**Expert Report on the Sio Silica Proposed  
Vivian Silica Sand Project**

The Rural Municipality of Springfield, Manitoba

Christopher J. Neville, M.Sc., P.Eng.

January 12, 2023

Figure 7. Simplified Thornthwaite-Mather analysis to estimate the average annual surplus

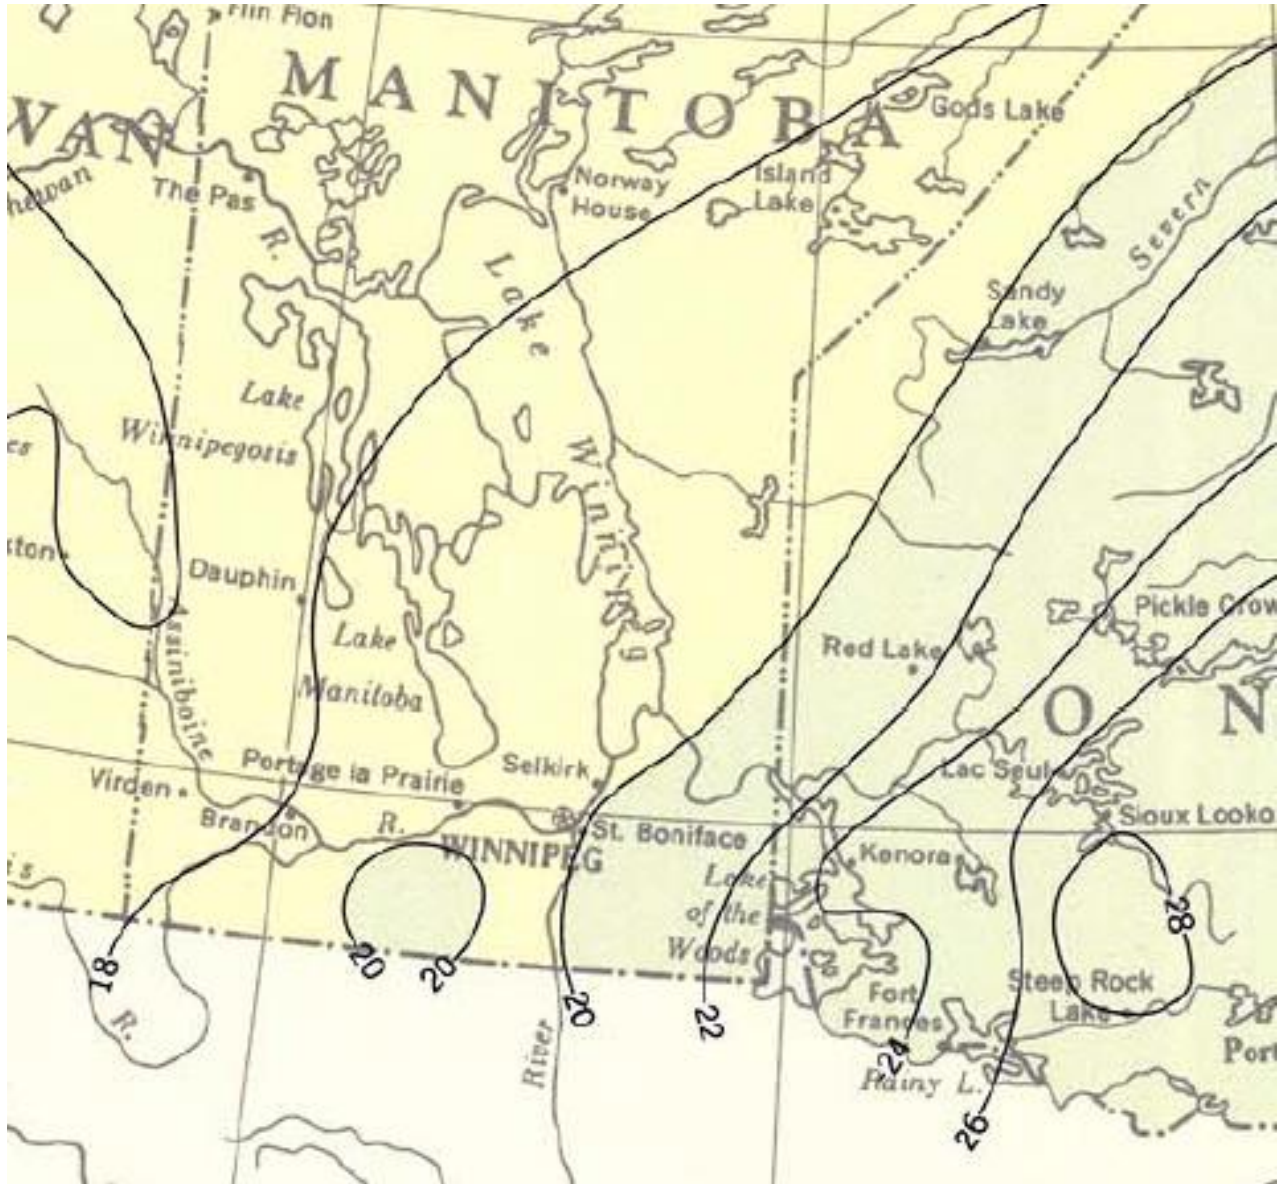
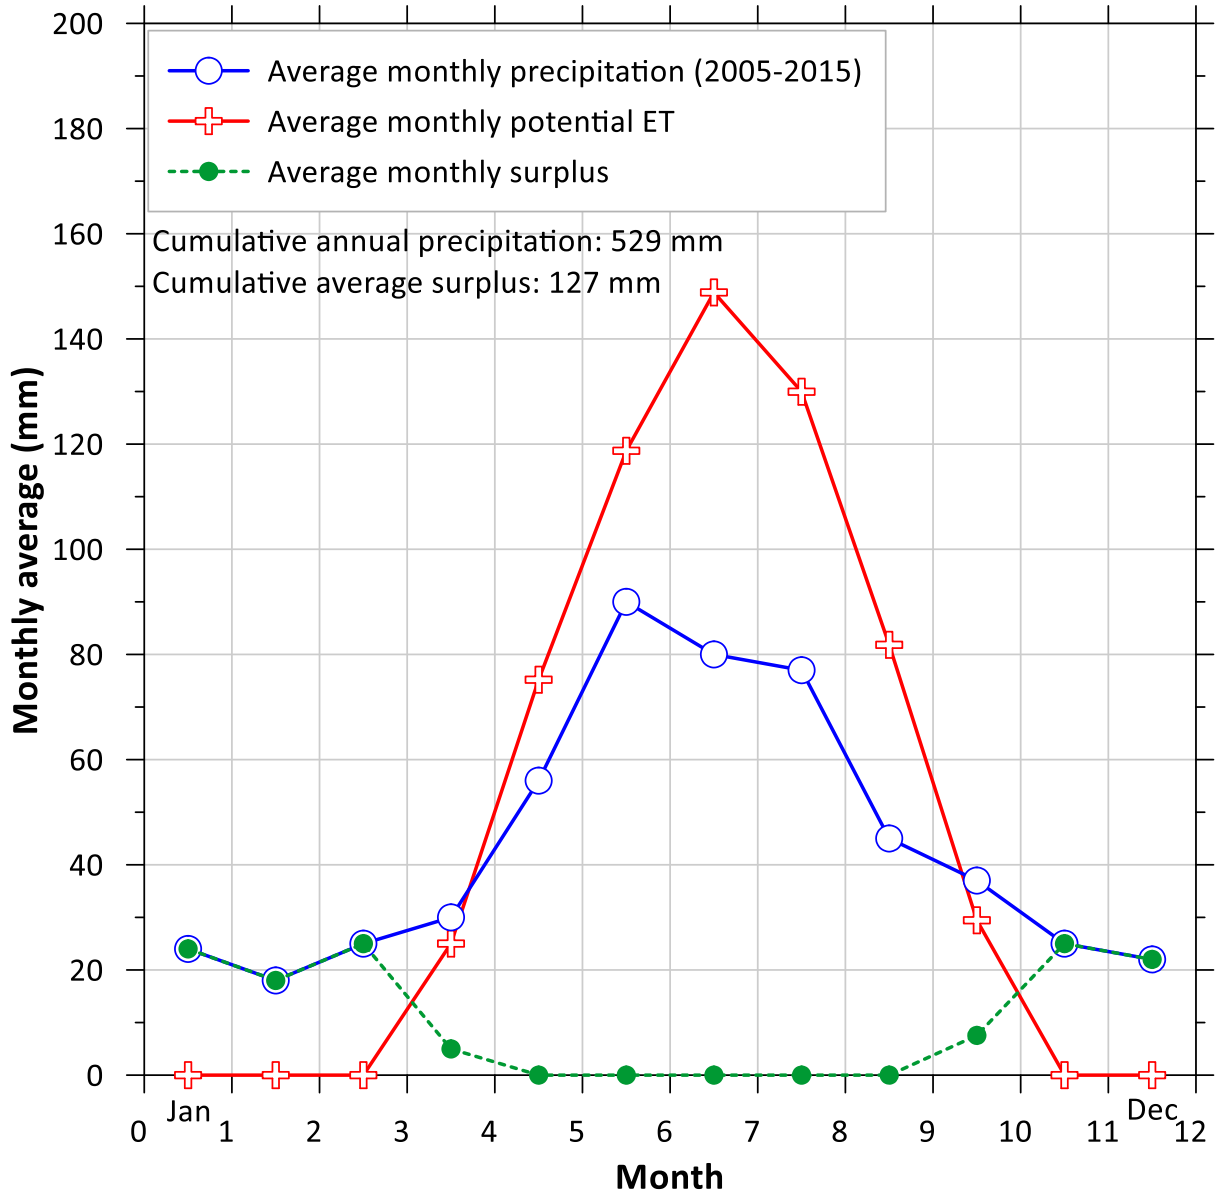
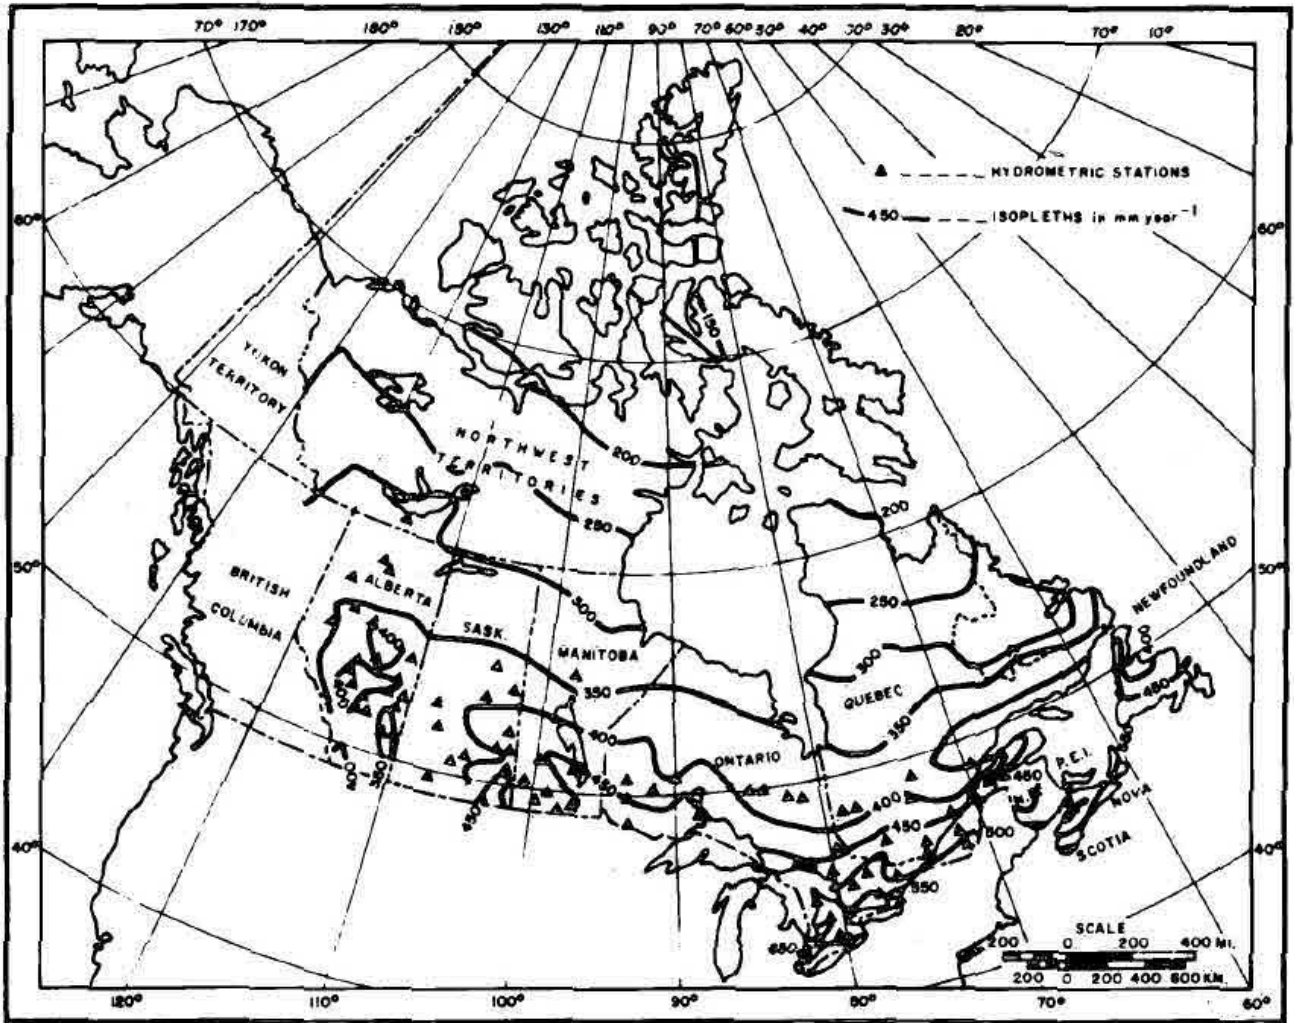
17. In my opinion, it is possible that the recharge over the model area is overestimated. It is indicated on Page 73 of the *Hydrogeology and Geochemistry Assessment Report* that the recharge is related to the mean annual precipitation at the Ostenfeld climate station for 1981-2020, 639 mm. Depending on the source, it appears that the average annual precipitation near Winnipeg is substantially less, between about 450 mm and 520 mm (see for example, <https://weather-and-climate.com/average-monthly-precipitation-Rainfall-inches,winnipeg,Canada> and <https://www.weather-atlas.com/en/canada/winnipeg-climate#snowfall>). Referring to the excerpt from the Atlas of Canada reproduced here in Figure 6, the average annual precipitation over the study area is about 21 inches (530 mm).

A simplified analysis of the precipitation surplus (Precipitation – Evapotranspiration), which represents the maximum amount of water that is available to recharge the water table, has been developed with the Thornthwaite-Mather analysis. According to the results of my calculations shown in Figure 7, the average annual surplus is about 130 mm. The implied annual evapotranspiration from the Thornthwaite-Mather analysis is 400 mm, which is roughly consistent with the average annual value of 450 mm mapped in Morton (1975) [see Figure 8].

The recharge rates applied for the Birds Hill and Sandilands areas of the groundwater model are substantially larger than 130 mm (250 mm/yr and 189 mm/yr, respectively). Specification of too high recharge rates will have the effect of attenuating the simulated effects of the proposed development. In my opinion, it is appropriate practice to obtain water budgets from the Engineering Climate Services of Environment Canada for several climate stations around the study area ([ec.scg-ecs.ec@canada.ca](mailto:ec.scg-ecs.ec@canada.ca)).

**Figure 9. Scatterplot for the steady-state model calibration**  
Adapted from AECOM (2021b; Figure 6-2)

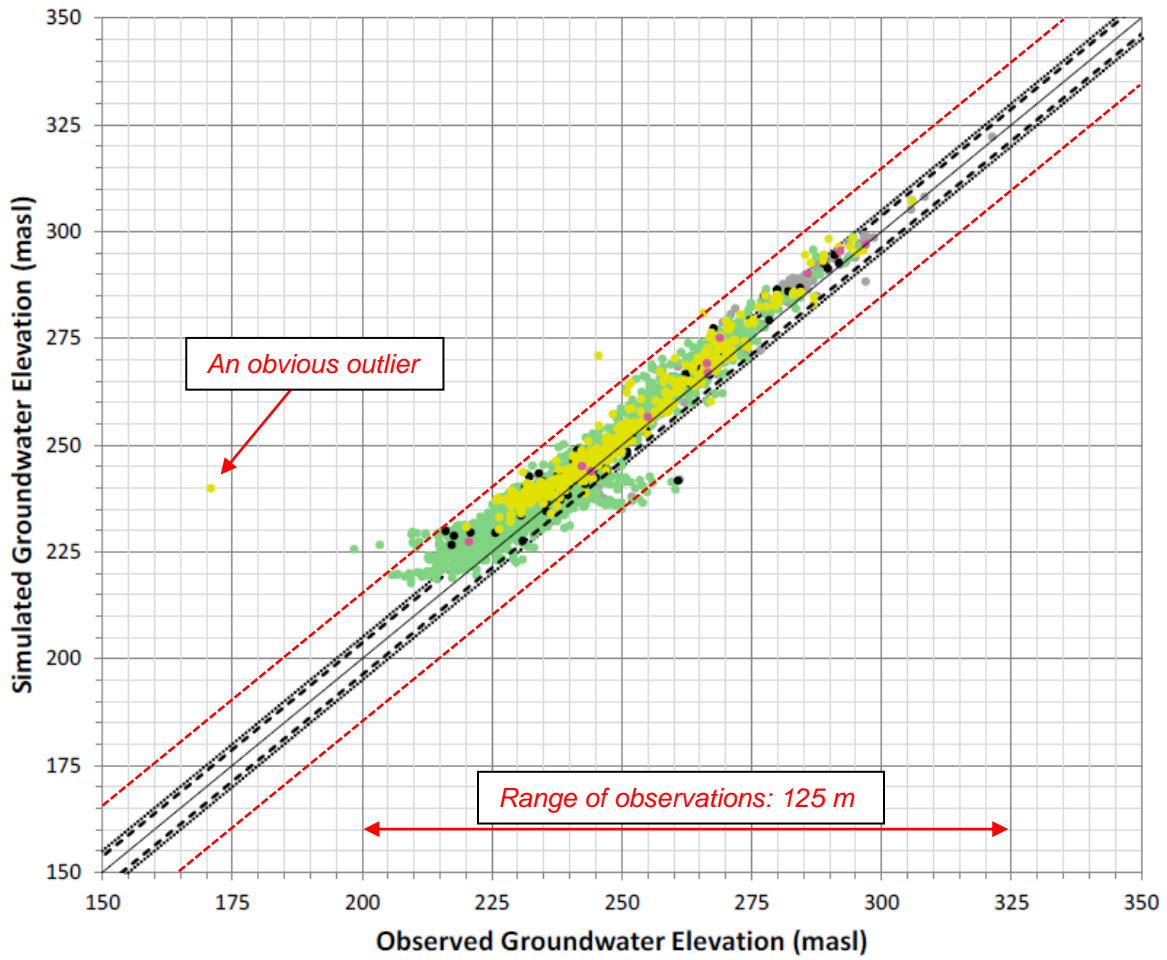
18. A scatterplot comparing the model results against the targets for the steady-state calibration is presented in Figure 6-2 of the *Hydrogeology and Geochemistry Assessment Report* and reproduced here in Figure 9. In my opinion, the scatterplot does not provide a convincing demonstration that the model has been adequately calibrated. I base my opinion on the following observations.

- No distinction is made between the reliability of the water levels that are used as targets. Average water levels estimated for dedicated observation wells installed for the project and the wells from the Manitoba Provincial Monitoring Program should be assigned higher weights in the calibration. In terms of the graphical presentation, the symbols for these wells should be prominent.

- As shown in Figure 9, the model exhibits a clear bias to overpredict water levels. The mean residual is 3.27 m.
- As indicated by the red dashed lines added in Figure 9, at the location of any particular target it appears that the mismatch of the model is likely on the order of  $\pm 15$  m. It may be debated that the Root Mean Square Error (RMSE) is a better measure of the local mismatch than the range of the errors estimated here by eye. Acknowledging this, it is still important to note that for this model the RMSE of 5.46 m is relatively large compared to the anticipated effects of the proposed operations.

- Although the Normalized Root Mean Square Error (NRMSE) is frequently adopted as a measure of the model goodness-of-fit, it is important to note that it is open to mis-application. In particular, the value of the NRMSE depends on the interpreted range of the observed water level targets. The NRMSE is defined as:

Noting that the reported RMSE is 5.46 m and the reported NRMSE is 1.70%, the back-calculated Range of Observations is 321.2 m. As shown in Figure 9, the range of the observations is more likely 125 m. With this range the NRMSE is re-calculated as 4.3%.

**Figure 10. Detail of calibration residuals near Winnipeg**  
Excerpt from AECOM (2021b; Figure 6-3)

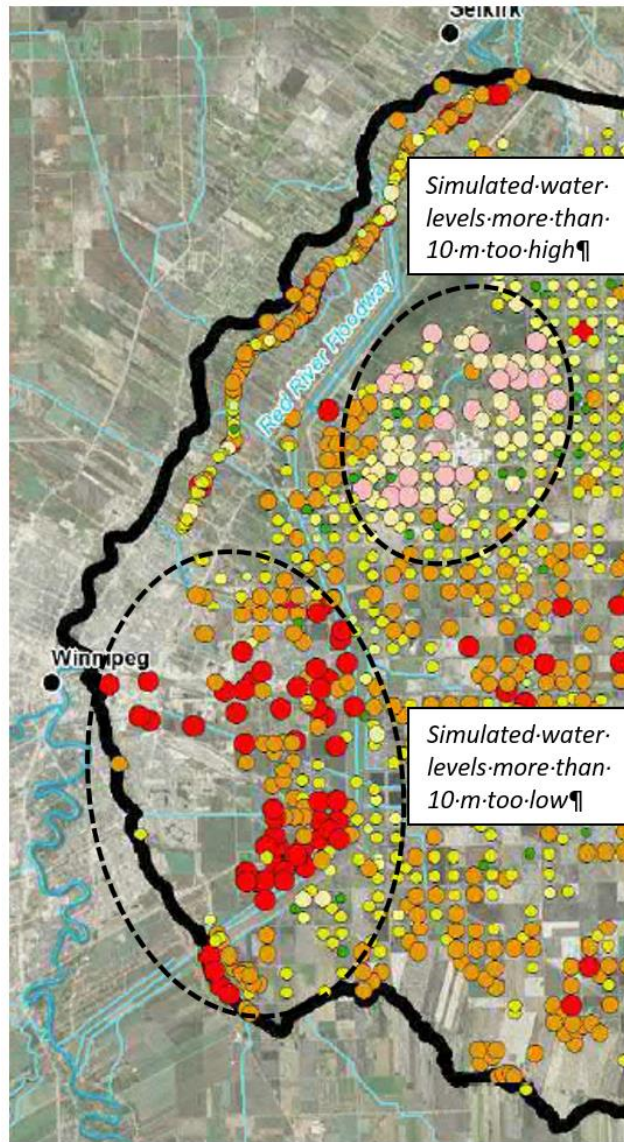
19. It is indicated on Page 72 the *Hydrogeology and Geochemistry Assessment Report* that at lower elevations, the calibrated steady-state groundwater model simulates groundwater levels that are higher than observed. The mismatch near Winnipeg is attributed to increased groundwater use in the area east of Winnipeg that is not accounted for in the modelling analysis. Based on my examination of Figure 6-3, the mismatch along the Red River is more suggestive of a problem with the model structure. As shown in the excerpt from Figure 6-3 shown here in Figure 10, there is an area close to Winnipeg where the simulated water levels are more than 10 m *lower* than observed (red circles; observed – simulated > 10 m). North of this area there is an area close to Red River Floodway where the simulated water levels are more than 10 m *higher* than observed (pink circles; observed – simulated < - 0 m). The large positive and negative residuals suggests that the boundary conditions may not be assigned appropriately.

Figure 11. Comparison of observed and simulated drawdowns for the Bru 95-7 pumping test

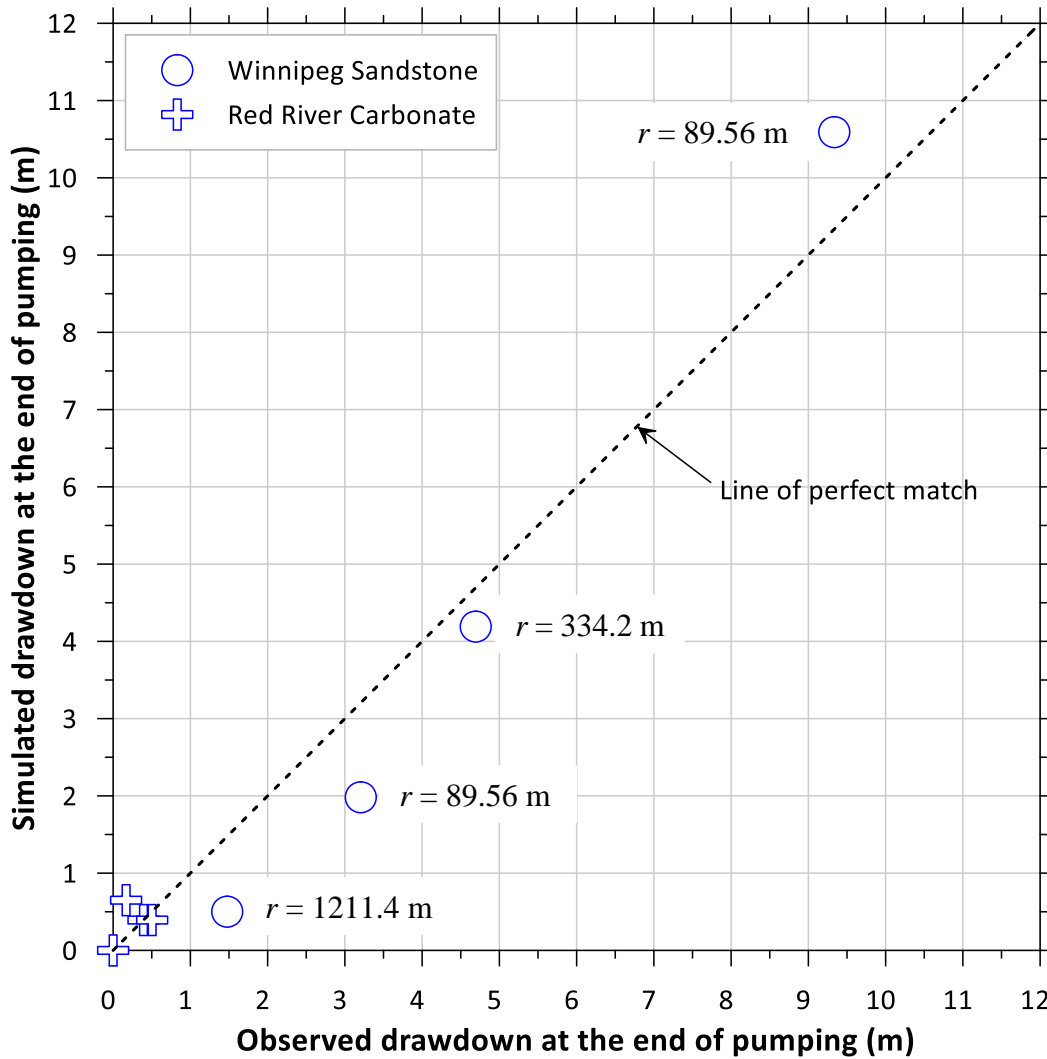
20. It is indicated on page 73 of the *Hydrogeology and Geochemistry Assessment Report* that at distances greater than 300 m the groundwater model simulates smaller drawdowns than were observed during the pumping test. This is highlighted in the comparison between observed and simulated drawdowns at the end of the pumping test. The drawdowns have been estimated from Figure 6-4. The results shown here in Figure 11 suggest that there is a systematic underestimation of the drawdowns at more distant locations in the Winnipeg Sandstone. This has important implications with respect to the impact assessment, as it is an indication that potential impacts on neighboring private wells may be underestimated.

**Figure 12. Summary of hydraulic conductivity estimates**

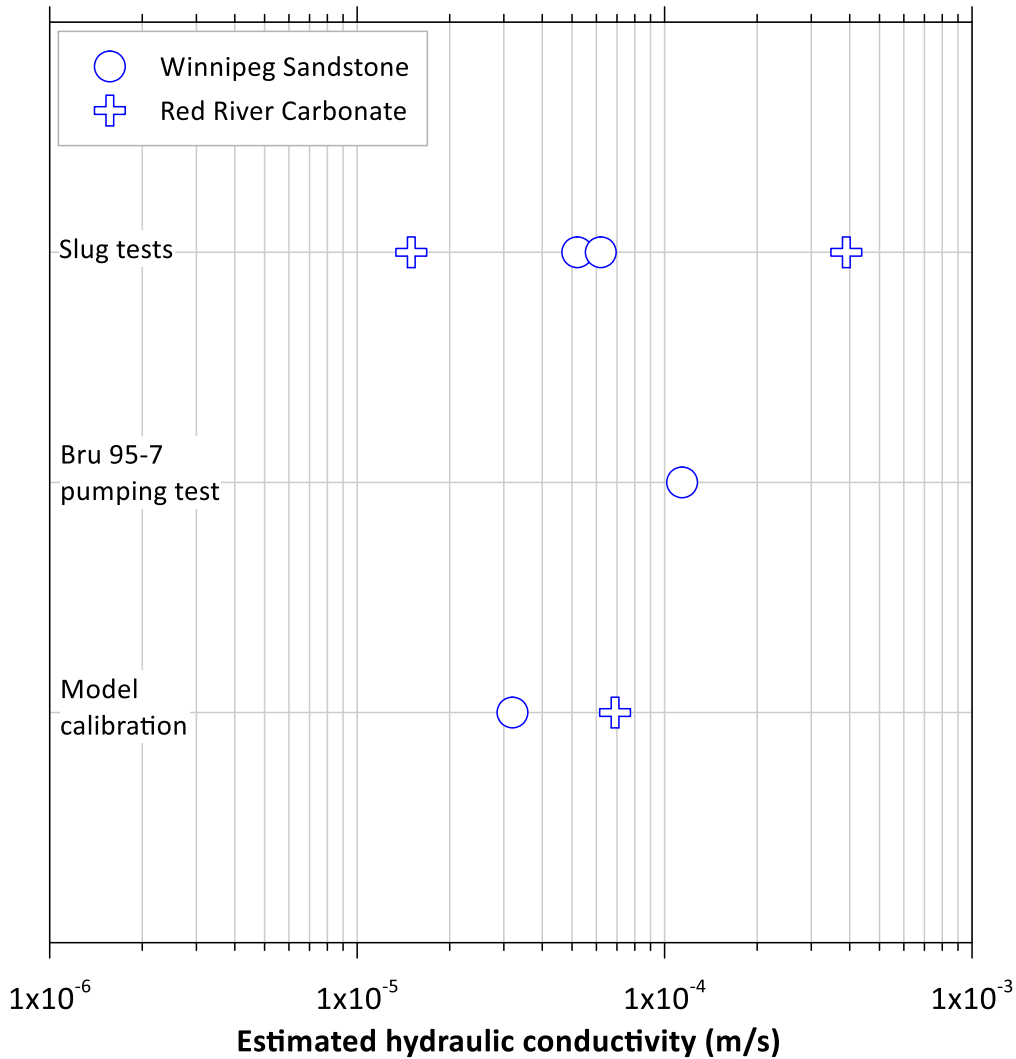
21. Limited data are available to assess whether representative values of the hydraulic conductivities of the Winnipeg Sandstone and the Red River Carbonate have been inferred through model calibration. As shown here in Figure 12, although the value of the hydraulic conductivity of the Winnipeg Sandstone specified in the groundwater model is consistent with the estimates obtained from the two slug tests, it is substantially lower than the value inferred from the pumping test. The hydraulic conductivity of the Red River Carbonate specified in the groundwater model is within the range of the two estimates obtained from slug tests, but the most important conclusion that might be drawn from the comparison is that the two slug test estimates vary by a factor of about 25.
